CHARTER TOWNSHIP OF GARFIELD
VIRTUAL PLANNING COMMISSION MEETING

Charter Township of Garfield Planning Department Report No. 2021-32			
Prepared:	March 3, 2021	Pages:	10
Meeting:	March 10, 2021 Planning Commission	Attachments:	<input checked="" type="checkbox"/>
Subject:	Burger King – Site Plan Review		
Applicant:	Jim Riemersma, JSR Construction		
Owner:	Casciano Traverse City, Inc.		
File No.	SPR-2021-01		
Parcel No.	05-014-049-80

Issued for:
REVIEW
Date
3-2-2021
Sht.No.
C-2
Job.No.
20-038

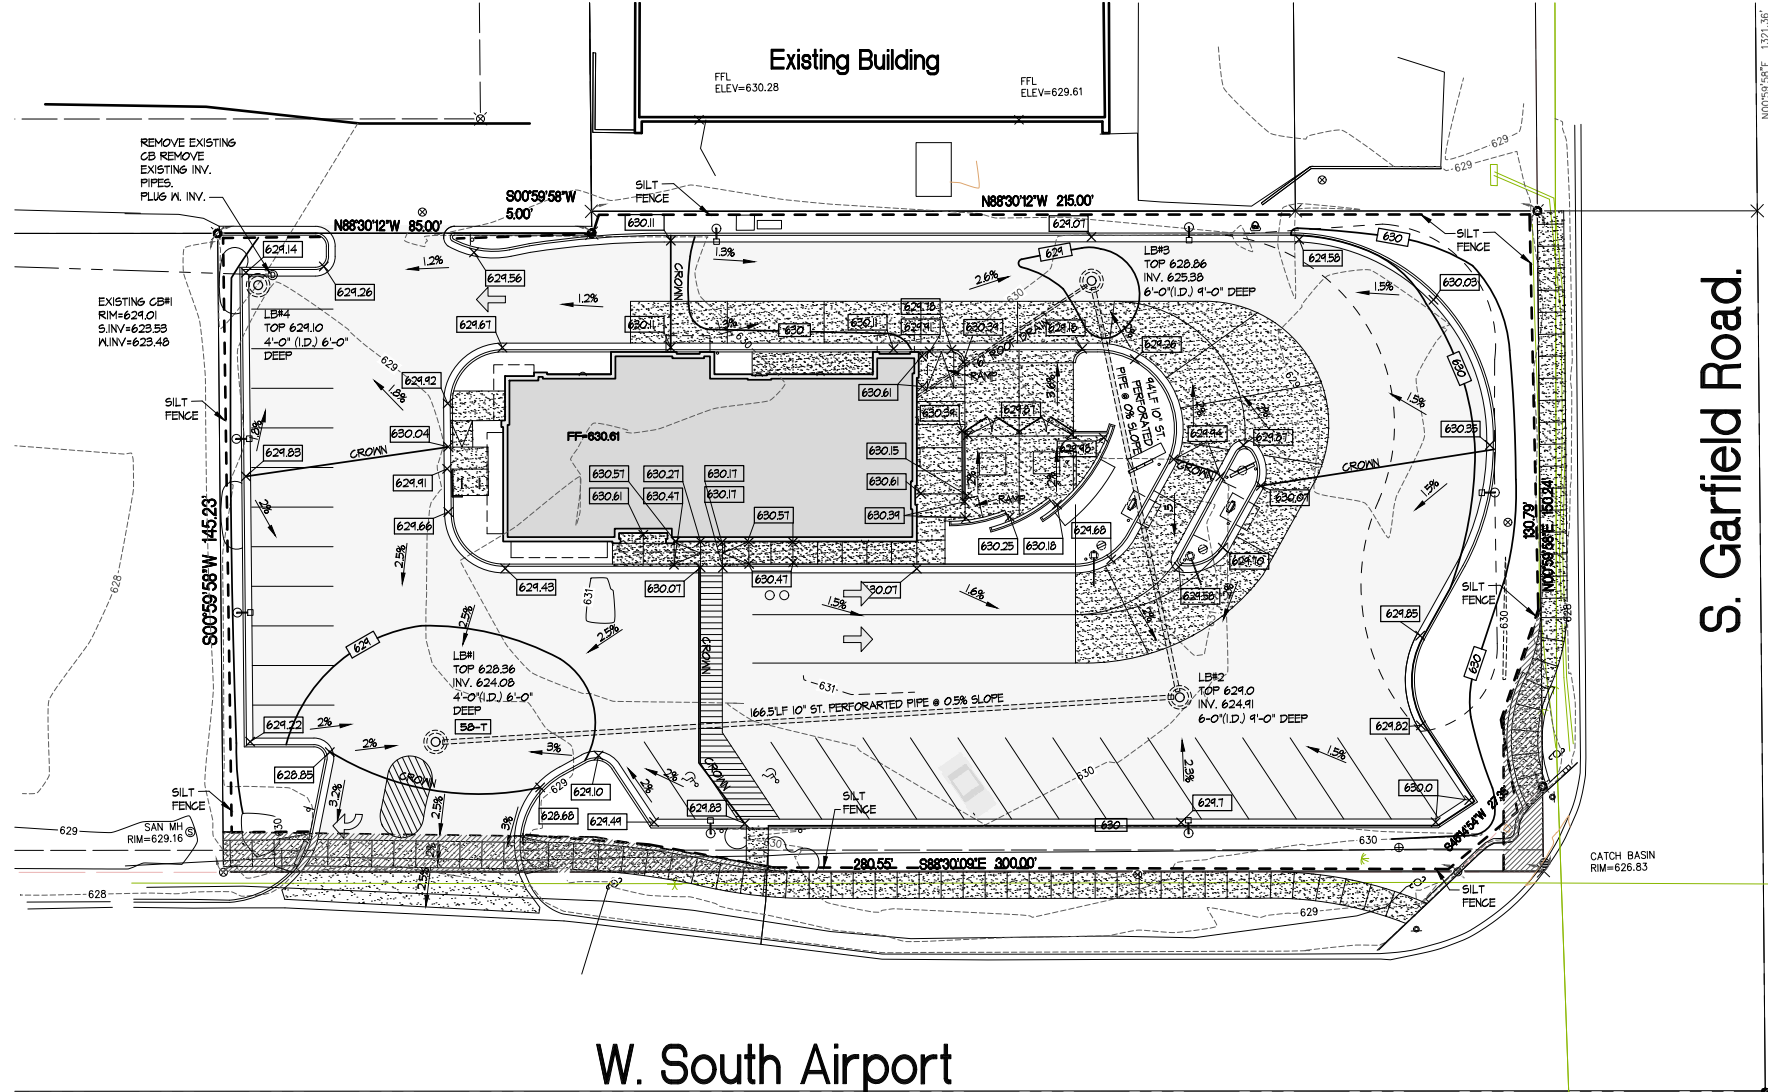
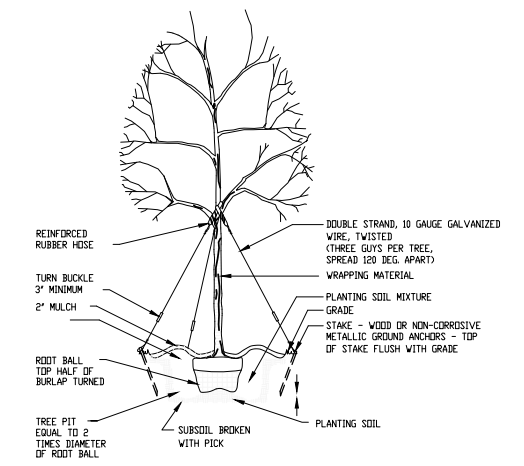
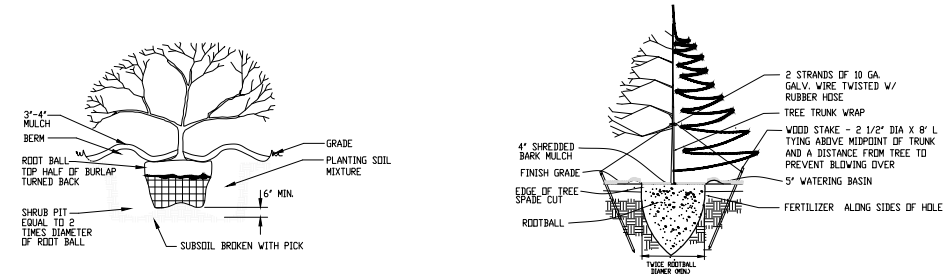
- The site plan shows the raised island in the middle of the ingress-egress drive is proposed to be removed. Staff is concerned this would likely negatively impact the safety of both pedestrian and vehicular traffic, particularly since the island helps prevent left turns from this drive onto South Airport Road. Staff discussed this issue with staff from the Grand Traverse County Road Commission who echoed these concerns and said that the design of the island may also be improved to reinforce desired traffic patterns. Site plan review will also include review from the County Road Commission.

As required by Section 551 of the Ordinance, a ratio of ten (10) square feet of snow storage is required per one hundred (100) square feet of parking area. This site plan indicates 29,160 square feet of parking space and maneuvering lane area and 2,916 square feet of snow storage required. The plan indicates 3,100 square feet of snow storage will be provided.

1. Record a public access easement for the proposed sidewalks.
2. The lighting and photometric plans shall be updated to meet illumination standards of Section 517 of the Zoning Ordinance, and a note shall be added to the site plan that these standards will be met.

3. A loading zone meeting all requirements shall be depicted on the site plan. This may be an off-hour loading zone.
4. A note shall be added to the site plan elevation drawings that all signs are subject to sign permit review.

Issued for:
 REVIEW
 Date
 3-2-2021
 Sht.No.
 C-3
 Job. No.
 20-038

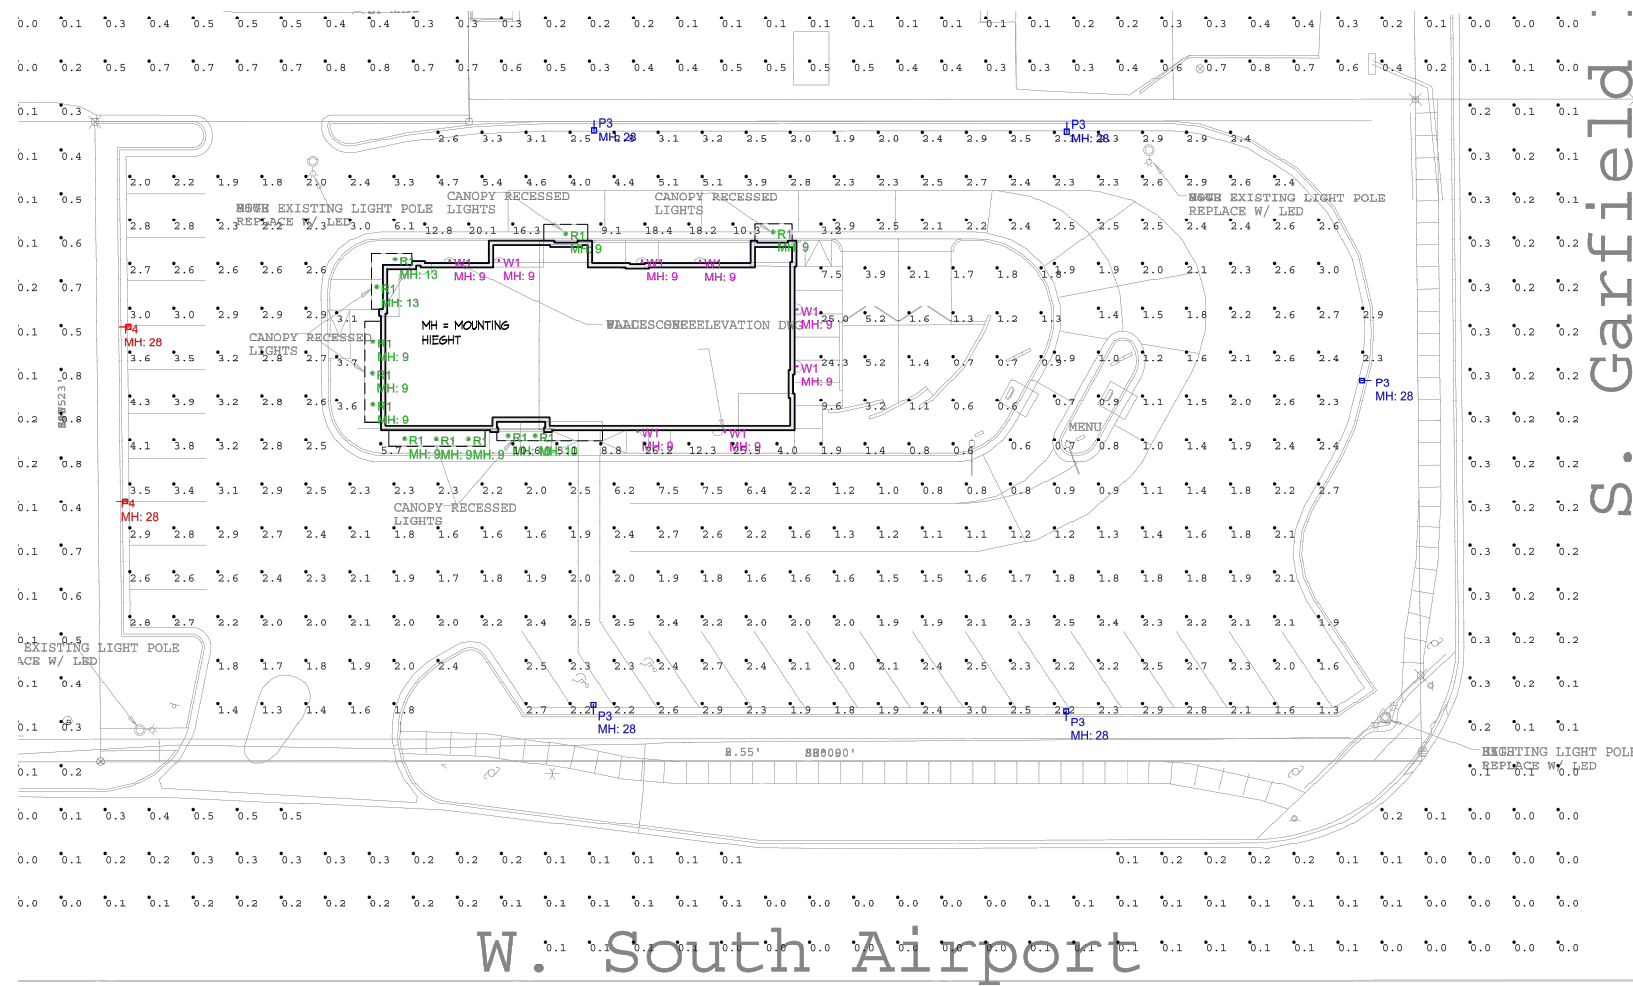
The letter from Innovative Design discusses the difficulty in fulfilling the landscaping requirements on the site, including the limitations given the size of the site. The applicant proposes the landscaping described above including buffers along both Garfield Avenue and South Airport Road that would be in line with the Type “B” rather than the Type “D” buffer and requests a waiver from the landscaping requirements from the Planning Commission.

Staff opinion is that the landscaping on the northern lot line is already well-established and the proposed landscaping on the western lot line is currently adequate, since to the west is an undeveloped parcel with unknown future development. Staff is of the opinion that the proposed landscaping along the eastern and southern lot lines provide a generally adequate buffer from the roadways, but there may need to be better screening of the menu boards on the Garfield Avenue side. The Planning Commissioners should consider requiring the applicant to provide additional screening of the menu boards, either with an island next to the drive-through lane or with additional screening directly along Garfield Avenue.

1 Dumpster Enclosure Plan
Scale 1/4" = 1'-0"

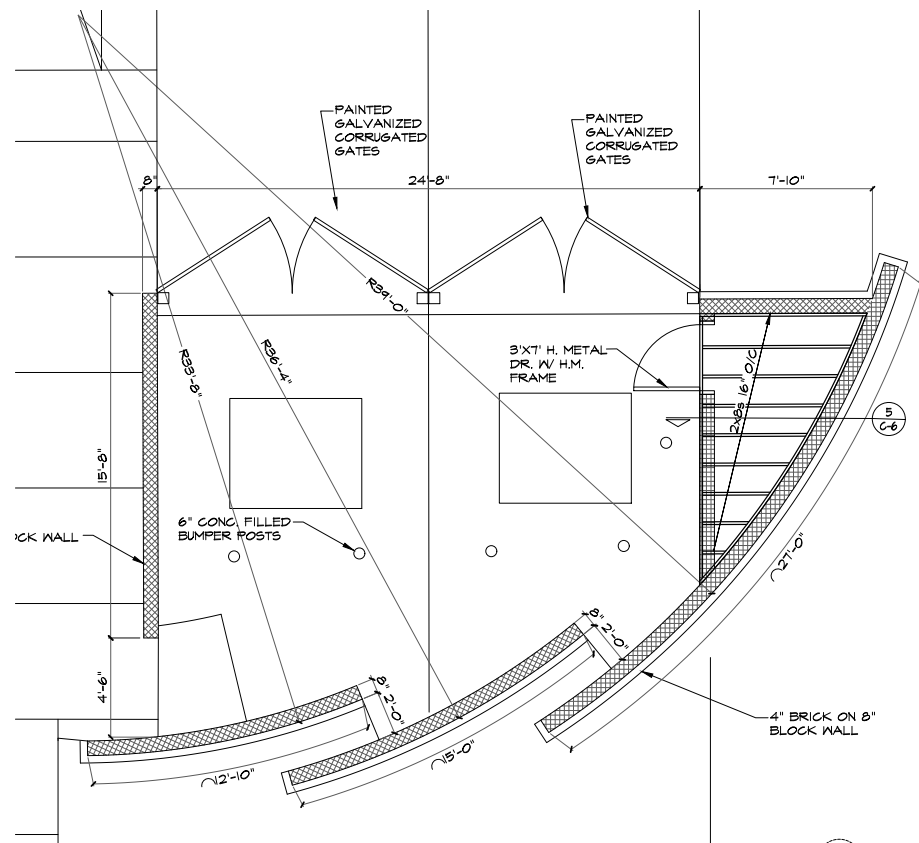
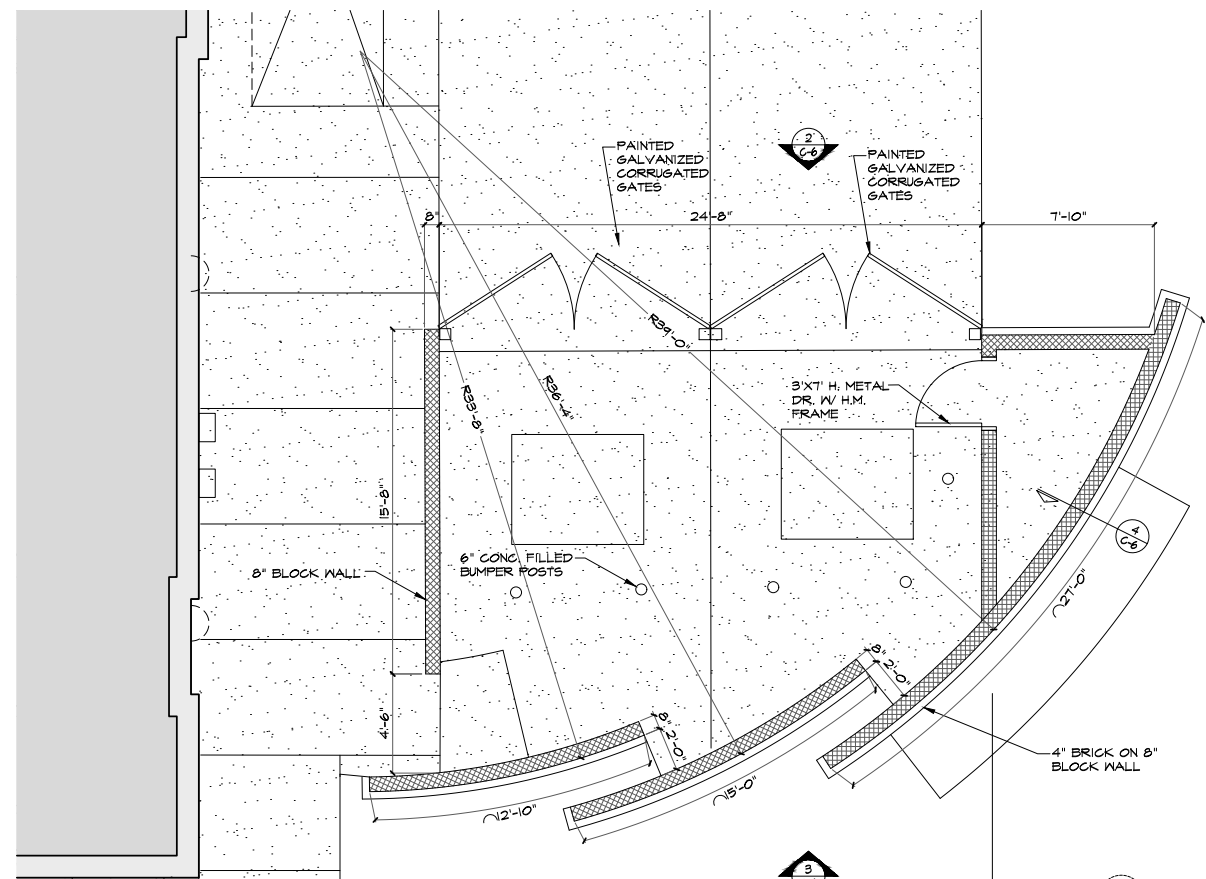
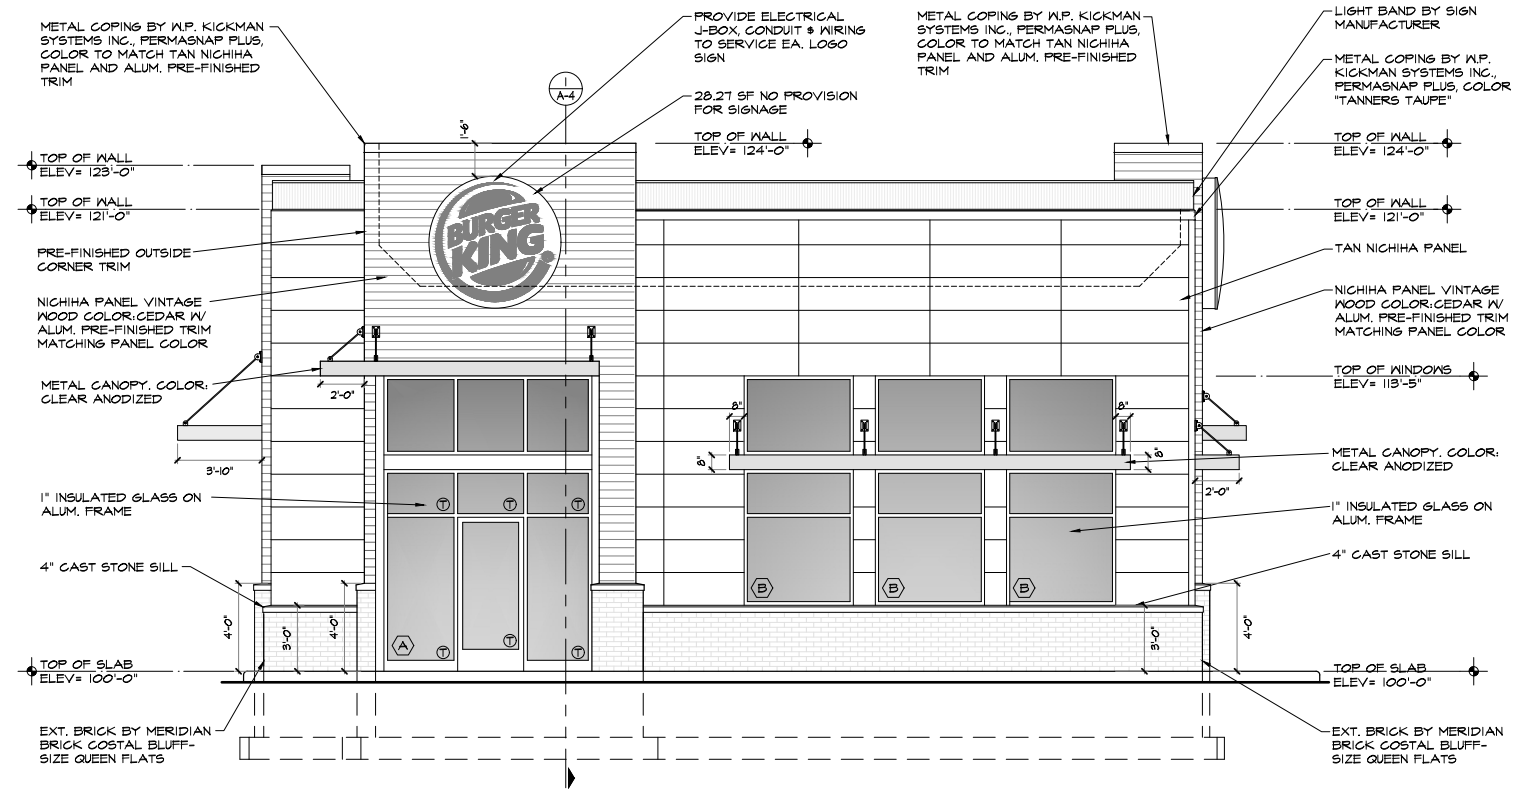
A dumpster enclosure is proposed just next to the building within the drive-through loop. Section 516 states that enclosures shall be finished with the same materials and colors as the exterior finish of the principal structure or shall be concrete block or similar material. Dumpster enclosure elevations have been included with the site plan and show the outside of the enclosure as brick to match the wall of the building. The enclosure also includes painted, galvanized, corrugated wood gates which are opaque and not plastic or vinyl slats. All standards of Section 516 appear to be met.
